ADDENDUM NO. 5
TO THE CONTRACT DOCUMENTS
for the construction of
McCroskey Island WWTP Expansion

Date: August 3, 2022
Project No.: C6A08007

City of Sevierville, TN
McCroskey Island Wastewater Treatment Plant

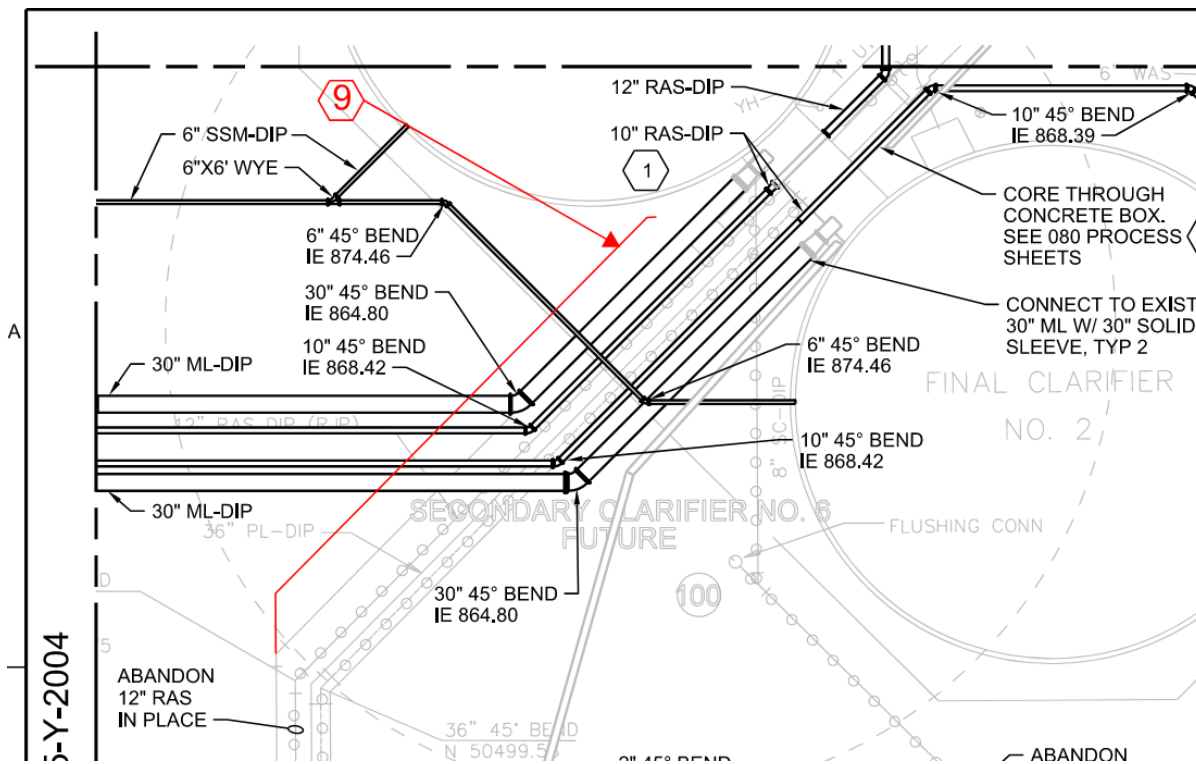
1. In response to Question #43, Drawing 005-Y-2005,
 ADD Keynote 9, “Field relocate and reconnect 2” W3-PVC. See Keynote 1.”;
 Grid Area A1, MODIFY the drawing as shown below:

- Response:** Two shifts of training which includes operational and maintenance training courses.
43. **Question:** Sheet 080-D-2002 shows a 2” W3 line feeding a hose bib. There’s a note referring us to see the civil drawings for continuation. The civil drawing 005-Y-2005 does not indicate this line. Please show where this line connects with the yard pipe.

- Response:** See PART 4, Drawings, Addendum #5.
44. **Question:** Vol. 2, 32 23 16. Addendum No. 3 outlined unit price work for over excavation for structures on the project site. Where does this quantity measurement begin? We’re assuming that this quantity measurement starts at the bottom of the 1’ minimum thickness granular fill layer? However, it can be assumed that this measurement starts at the lowest undercut elevation shown in the plans. For example, plan sheet 050-S-3001 (Biological Train No. 2) shows the lowest undercut elevation at 860.00. Would the undercut measurement start at elevation 869.00 (bottom of the 1’ granular fill layer) or at elevation 860.00 (bottom of the undercut shown on plan)?
